**Re: GE-Pittsfield/Housatonic River Site  
Hill 78 Area-Remainder (GECD160)  
Addendum to Final RD/RA Work Plan**

By letter dated August 20, 2008, EPA conditionally approved the Final RD/RA Work Plan and required submittal of an Addendum to the Final RD/RA Work Plan within 30 days of the date of that letter (i.e., by September 19, 2008). In response to the conditions set forth in that letter, this *Addendum to Final RD/RA Work Plan* (Addendum) summarizes and addresses each of EPA's approval conditions and presents certain modifications to the Final RD/RA Work Plan. The soil-related Response Actions at Hill 78 Area-Remainder will be conducted in accordance with the Final RD/RA Work Plan, as modified by this Addendum.

**DETAILS**

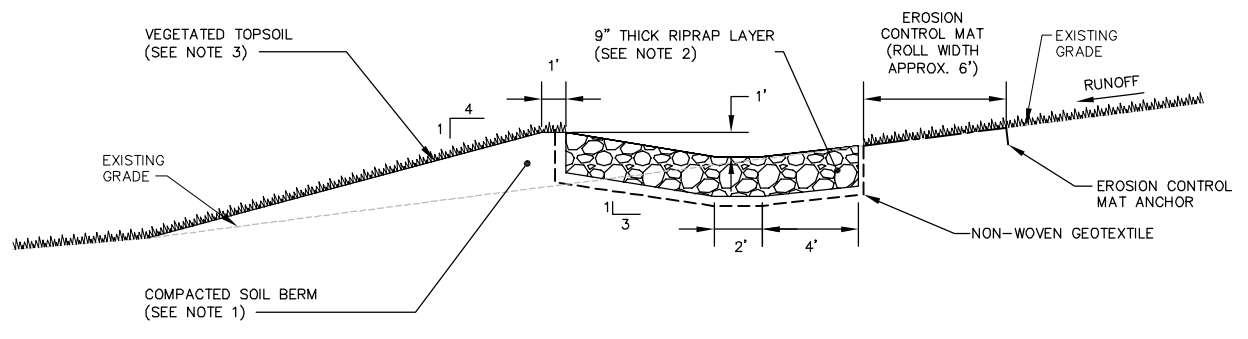
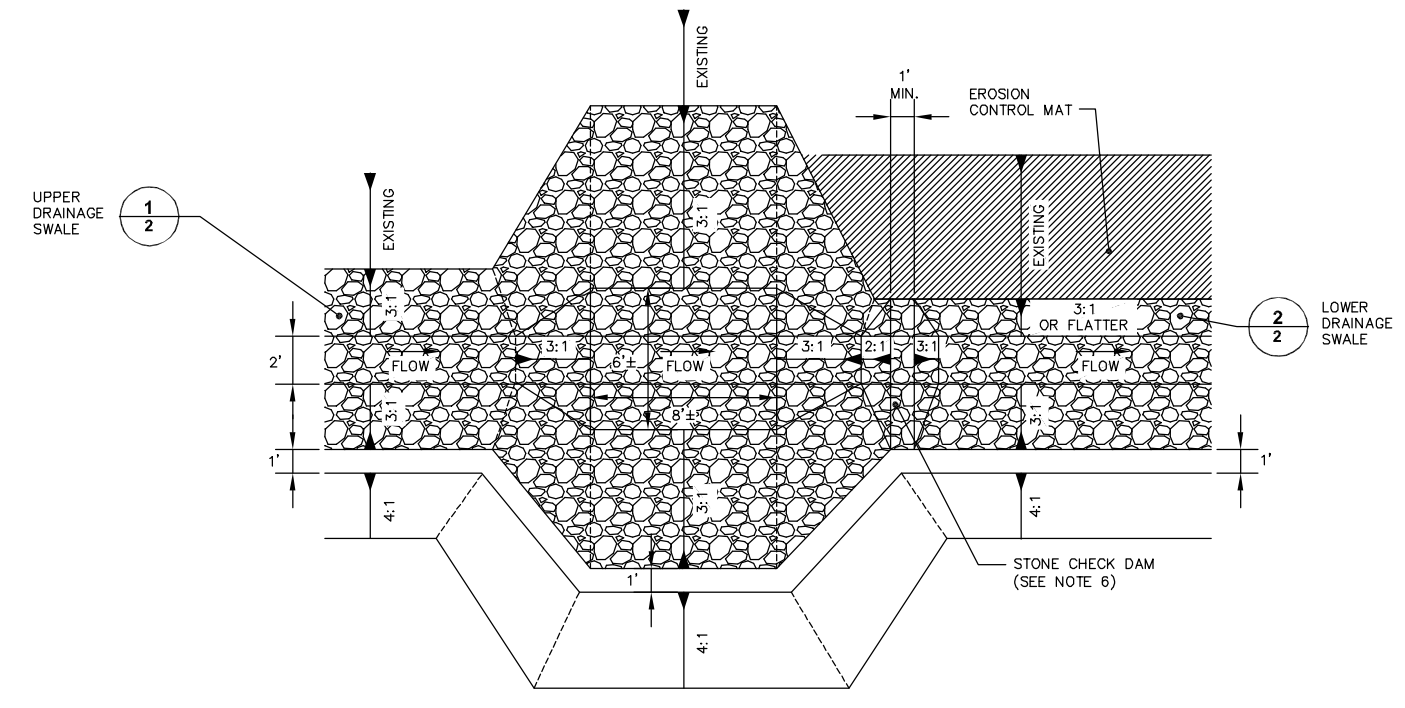
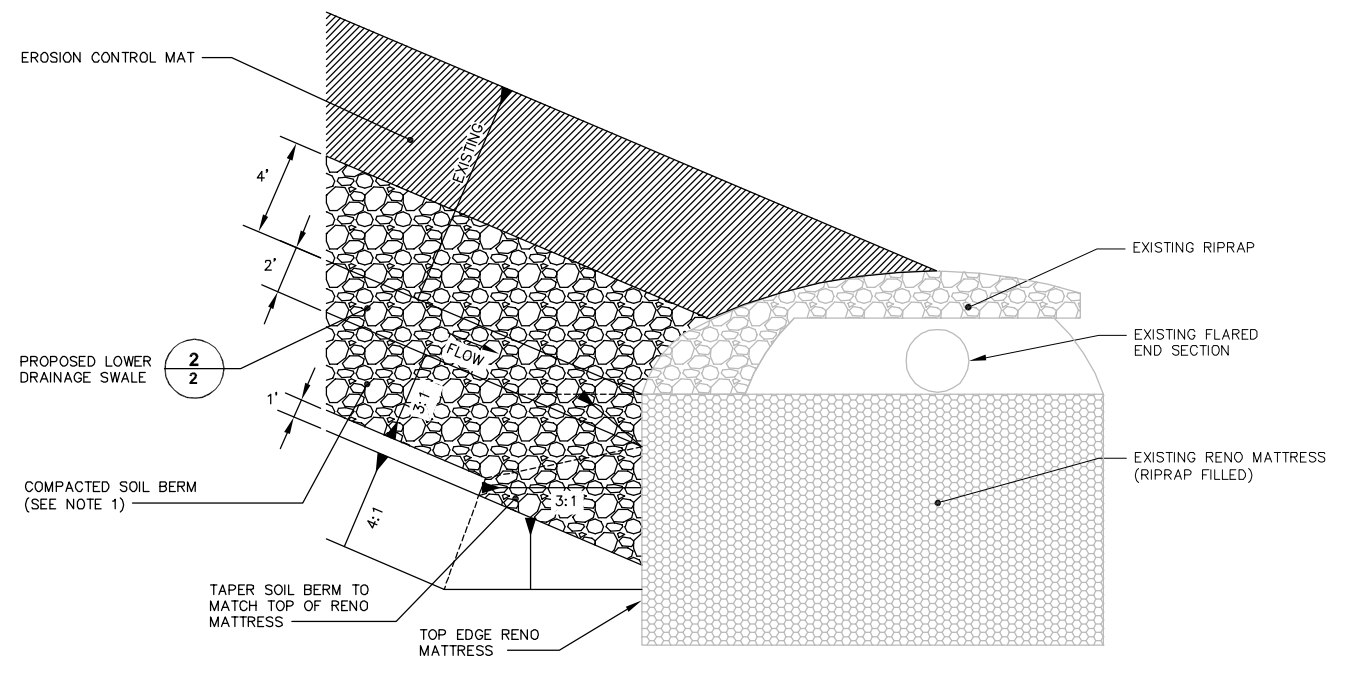
**EPA CONDITION 4:** *GE shall restore the areas impacted by the storm and sanitary sewer pipeline realignment activities prior to, or in conjunction with, the backfilling and restoration activities associated with the remediation described in the Work Plan. GE shall incorporate a restoration plan into the Post-Removal Site Control Plan for the Hill 78 Area-Remainder RAA which illustrates the locations of the new swales and other restoration components for the sewer pipeline realignment area, and documents the inspection activities to be performed.*

The proposed drainage swale will be constructed to manage stormwater runoff from upgradient areas, including areas that were re-graded during sewer relocation activities. The proposed swale will commence along the toe of the slope south of the Hill 78 OPCA access road and will convey stormwater south to the existing riprap outlet. The proposed swale, which will include a stone check dam, will be configured as shown on Drawing No. 2 (Attachment B).
